Access Compliance Report

Public Rights-of-Way

(Curb Ramps)

Intersection ID: 16072	Main Street: MONROE_RD	Cross Street: RICHLAND_DR	Location: SW
ADA ID: 8615E00A3790	Ramp Type: Para	Initial Pass/Fail: Pass	Overall Compliance: No
Severity Score: 15.25			
Codes/Mitigation Info/Possible Solution		Field Measurements/Component Compliance

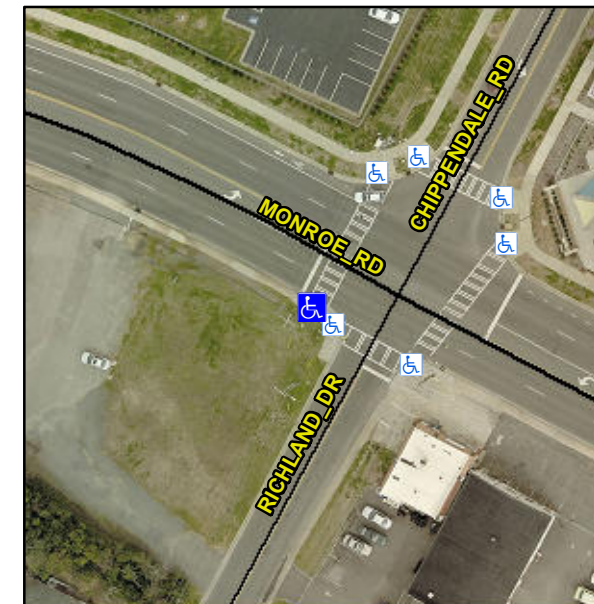
RT RP < 5%

R304.5.3, R304.2.1, R304.2.2-Perp,
R304.3.2-Para, R304.5.4

Compliance	Description	Data	Compliance	Description	Data
N/A	Ramp Length LT (in)	40.0	N/A	Ramp Length RT (in)	58.5
Yes	Ramp Width LT (in)	73.0	Yes	Ramp Width RT (in)	57.5
Yes	Ramp Slope LT (%)	5.3	Yes	Ramp Slope RT (%)	4.6
No	Ramp XSlope LT (%)	2.1	Yes	Ramp XSlope RT (%)	0.7
No	Landing Length (in)	N/A	Yes	DWS Provided?	Yes
No	Landing Width (in)	N/A	Yes	DWS Contrast?	Yes
No	Landing Slope (%)	N/A	Yes	DWS Length (in)	24.0
No	Landing X Slope (%)	N/A	Yes	DWS Full Width?	Yes
N/A	Landing Curb? (Y/N)	Yes	Yes	DWS Offset (in)	0.0
N/A	Shared Landing?	No			
Yes	Gutter Ponding?	No	No	Gutter Slope (%)	7.8
Yes	Gutter Lip Ht (in)	0.0	No	Gutter X Slope (%)	2.2
N/A	Painted X Walk1?	Yes	N/A	Painted X Walk2?	N/A
	X Walk 1 Direction	To N		X Walk 2 Direction	N/A
N/A	X Walk 1 Width (in)	114.0	N/A	X Walk 2 Width (in)	N/A
	X Walk 1 Slope (%)	2.6		X Walk 2 Slope (%)	N/A
	X Walk 1 X Slope (%)	0.4		X Walk 2 X Slope (%)	N/A
Yes	Ramp inside XWalk1?	Yes	N/A	Ramp inside XWalk2?	N/A

Remove & Replace Entire Ramp.
Remove & Replace Gutter.
